CERTIFICATE OF APPROPRIATENESS

Applicant: Phil Arnett for 2315 Union Street, LLC, owner

Property: 2315 Union Street, Lot 11, Block 384, Baker W R NSBB Subdivision. The property includes a historic 900 square foot, one-story wood frame single-family residence situated on a 5,000 square foot (50' x 100') interior lot.

Proposal: Alteration –

WEST SIDE ELEVATION

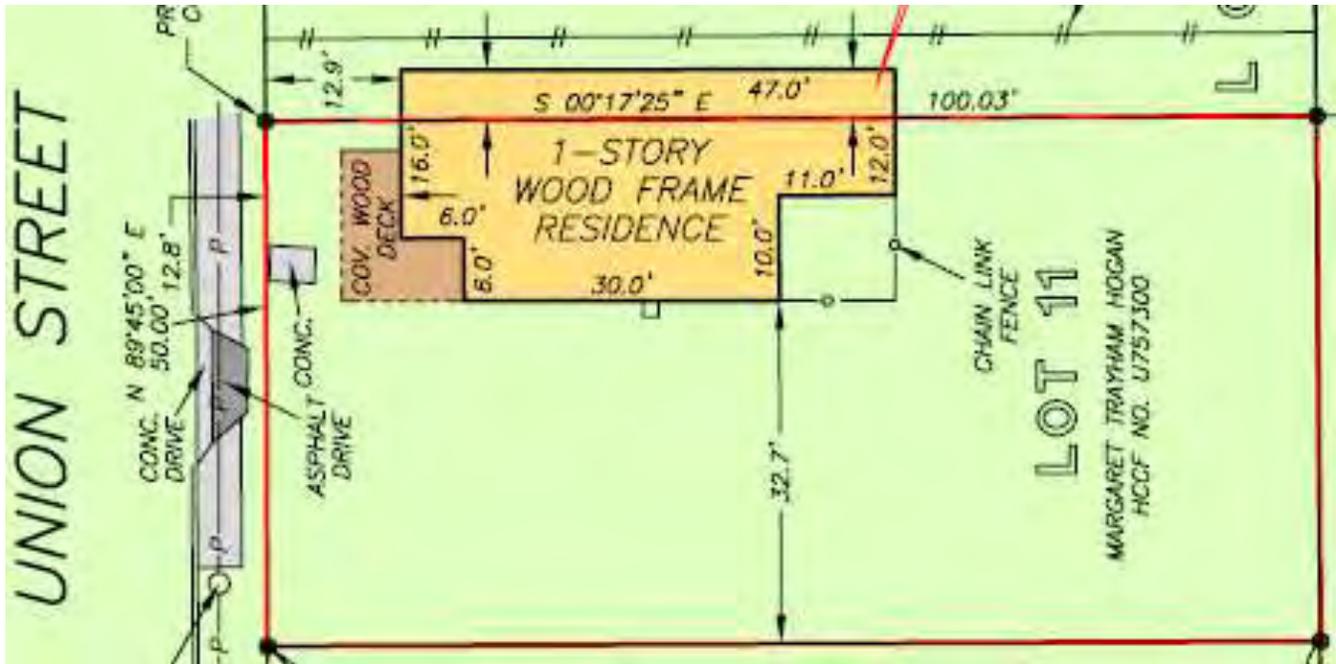
- We support consolidating the shorter double windows on the west elevation into a single window.
- We reviewed the window specifications that you sent. Based on what you sent, it appears the windows are integral risling fin (otherwise known as flush mount). We request that you instead use 4-over-4, not flush-mount windows with real divided lights (as opposed to snap-ins). Attached please find an early photograph showing that the house originally featured 4-over-4 windows. For this particular manufacturer, this means using fixed frame or pocket replacement, and with flat moulting (5-1/2") as specified on the manufacturer's website. We might be interested in working with you to use what the manufacturer calls "simulated divided light," rather than "removable wood grilles."

- **The non-original aluminum windows be replaced with 4-over-4 traditionally mounted sash windows with exterior muntins.**
- **The existing double window on the west elevation be returned to its original fenestration pattern with a single window.**
